# PAINT BRUSH HILLS FILING 14 RELIMINARY PLAN

## PAINT BRUSH HILLS FILING 14 PRELIMINARY PLAN

## 08/24/2020 EPC SUBMITTAL

# Prelim Plan\_v1\_redlines.pdf Markup Summary

## CS01

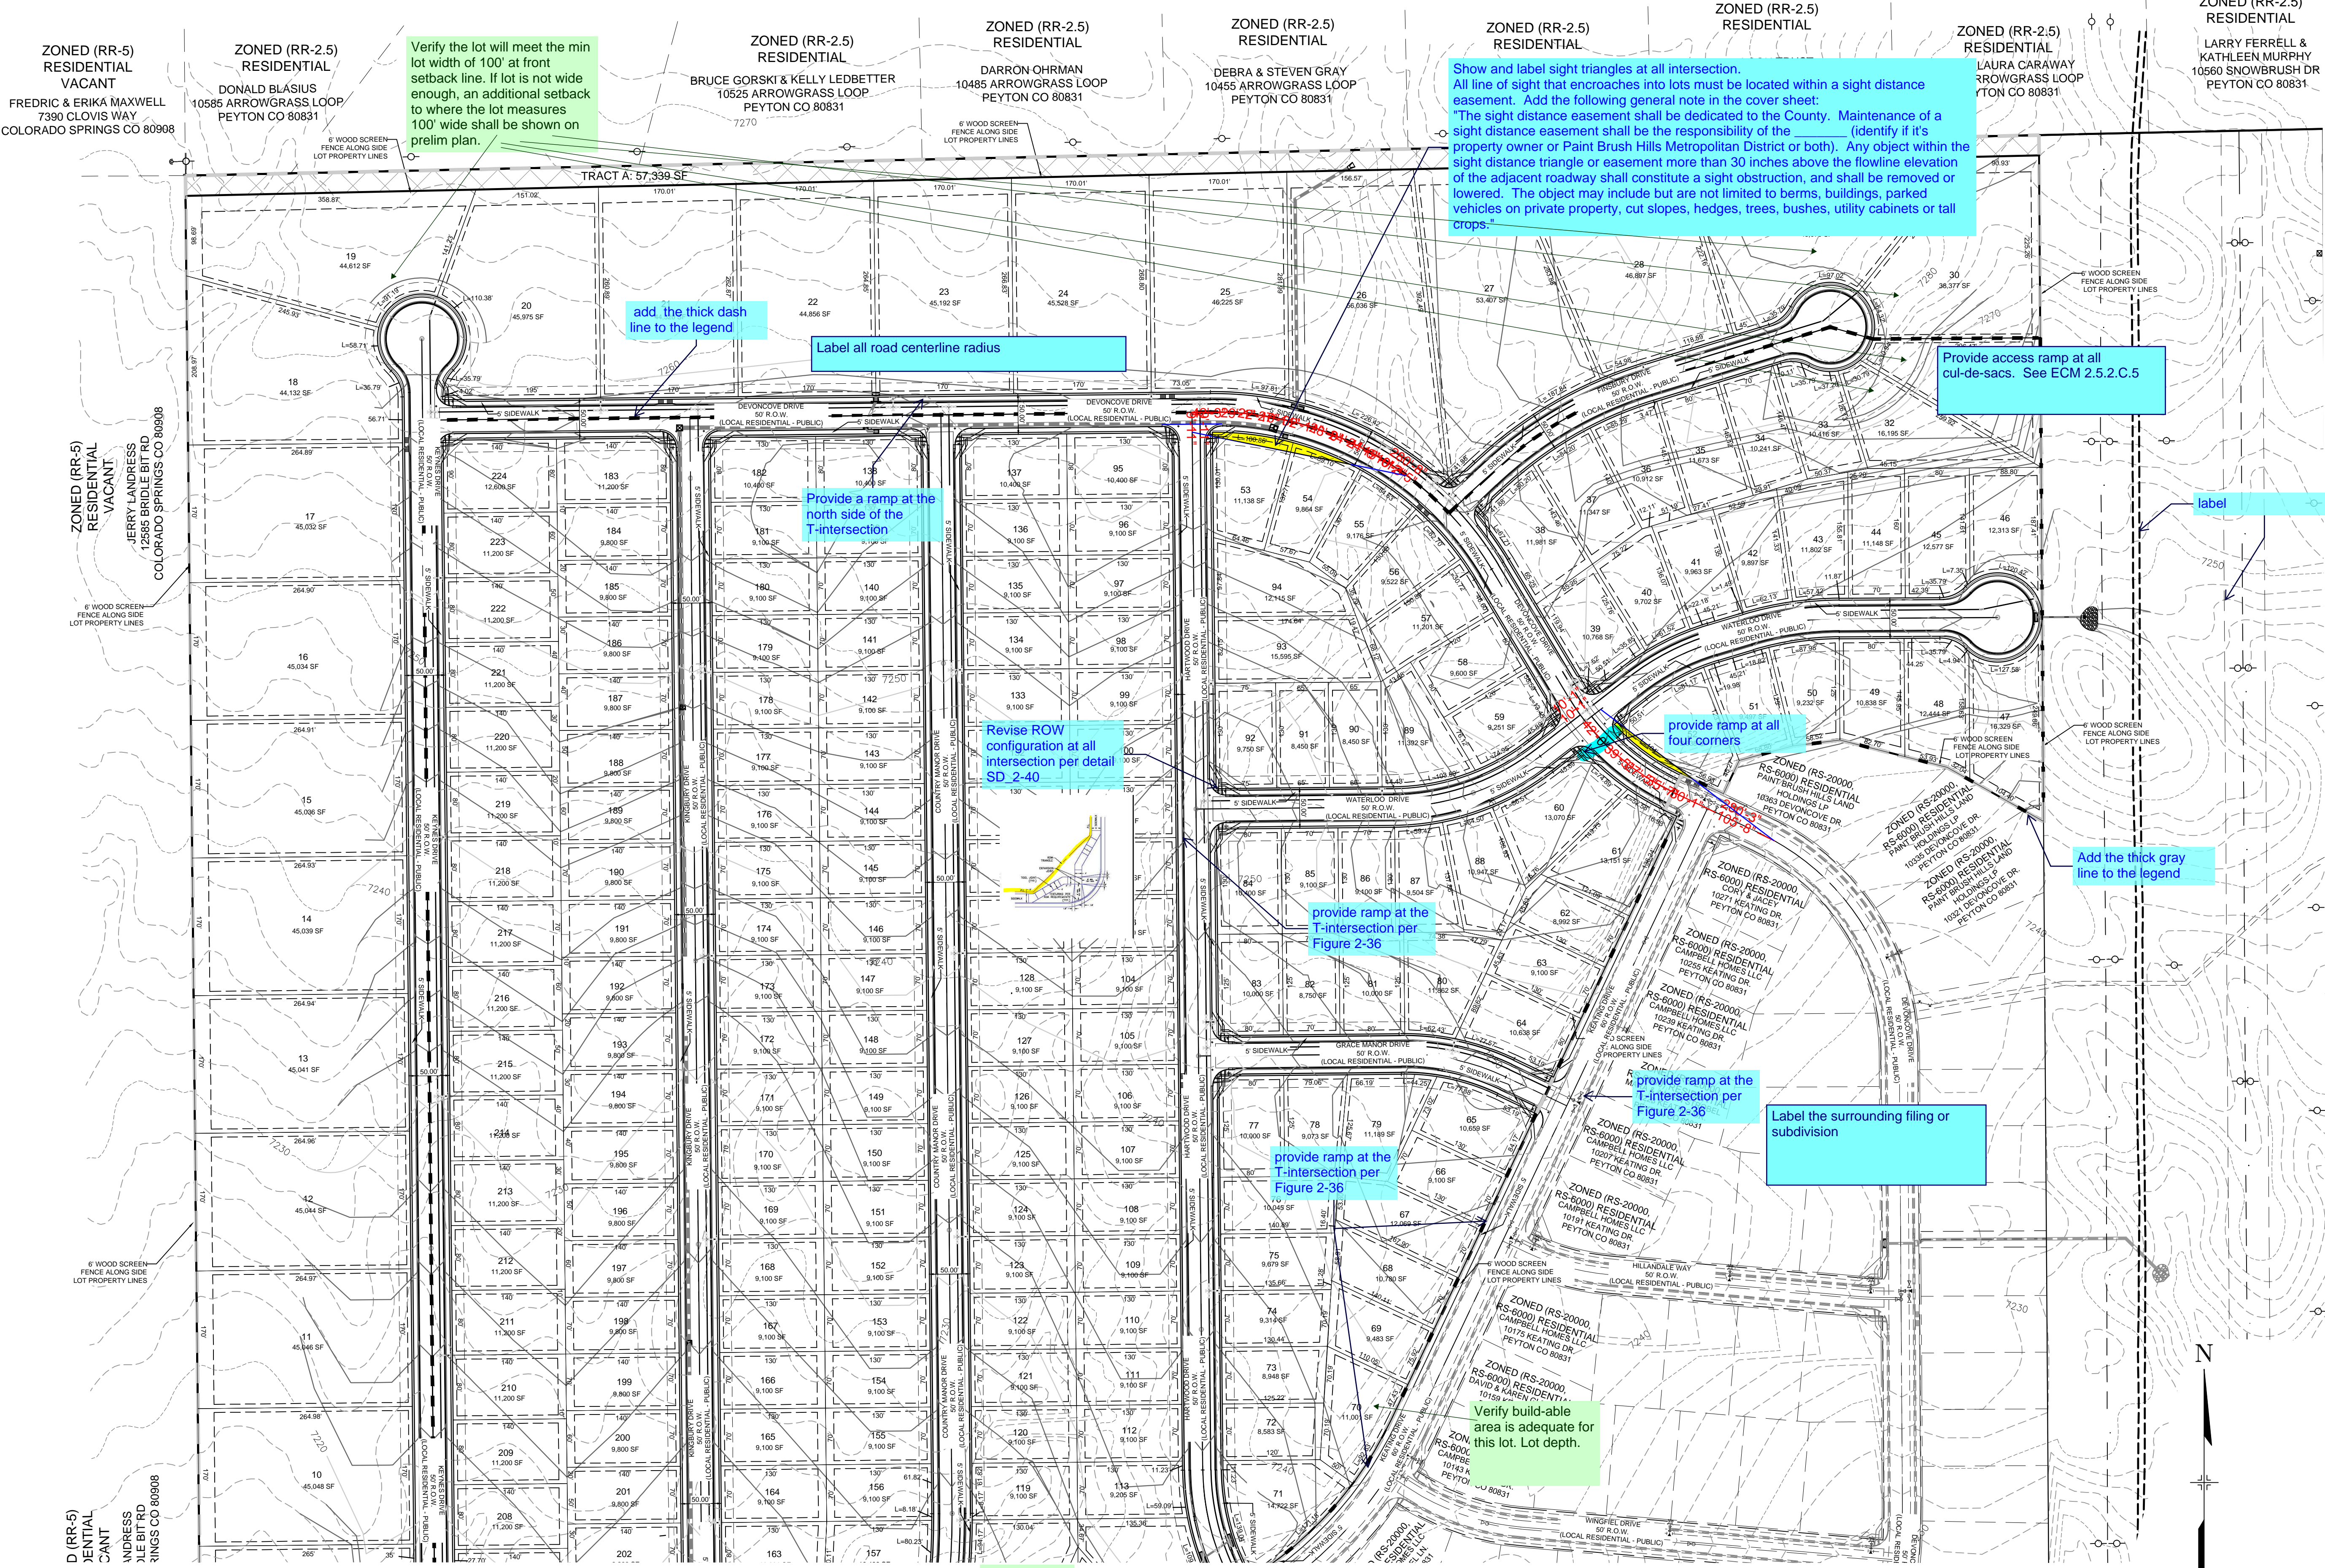
4. All Electric Service shall be provided by Mountain View Electric Association. Utility easements will be provided as required. **Add gas provider**
5. See Grading Plan for proposed site grading.

If lighting is proposed within the ROW, provide details at final plat stage and a license agreement is required for lights in the ROW.

Revise to reflect mitigation required in the soils and geology report. Engineered foundation and perimeter or underdrains.

Add a legend and abbreviation list

For your information: ECM Detail SD\_2-2 only requires a 5' public improvement easement

Revise to "EPC Optional Type C"

Add "SP206"

**SP02  
 SHEET 3 OF 5**

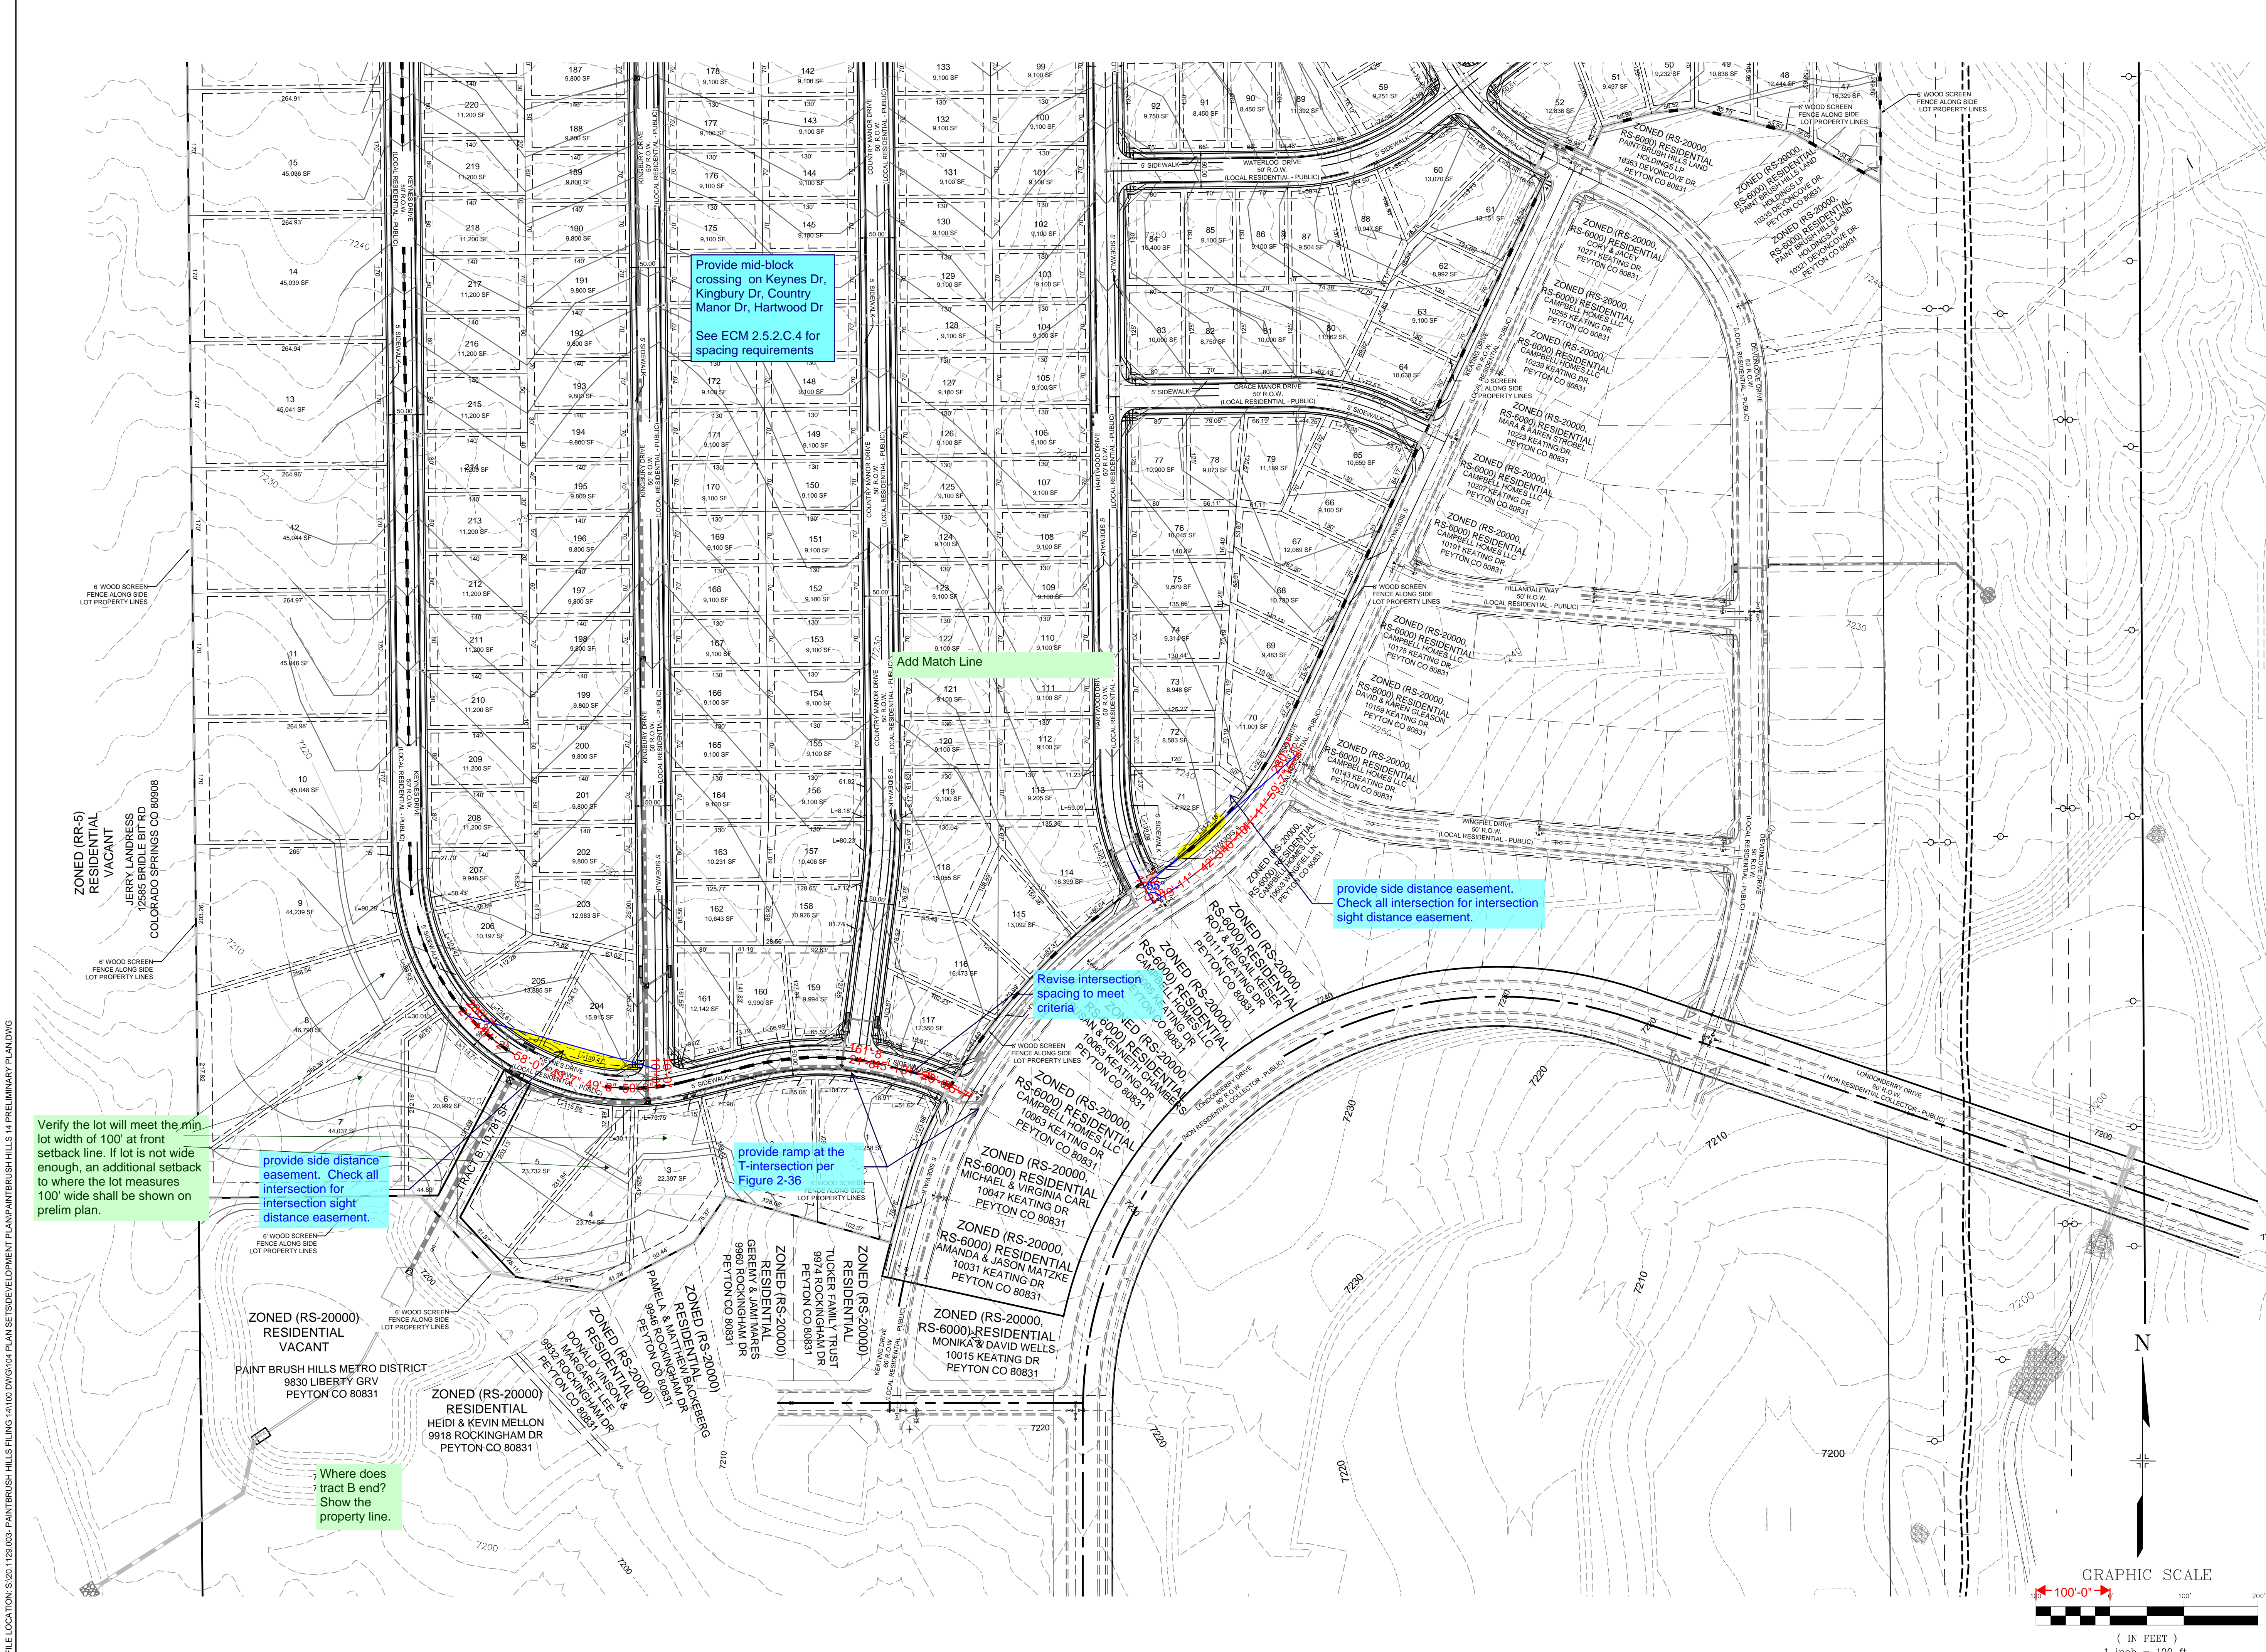
provide side distance easement. Check all intersection for intersection sight distance easement.

Revise intersection spacing to meet criteria

Provide mid-block crossing on Keynes Dr, Kingbury Dr, Country Manor Dr, Hartwood Dr

Add Match Line

Where does tract B end? Show the property line.
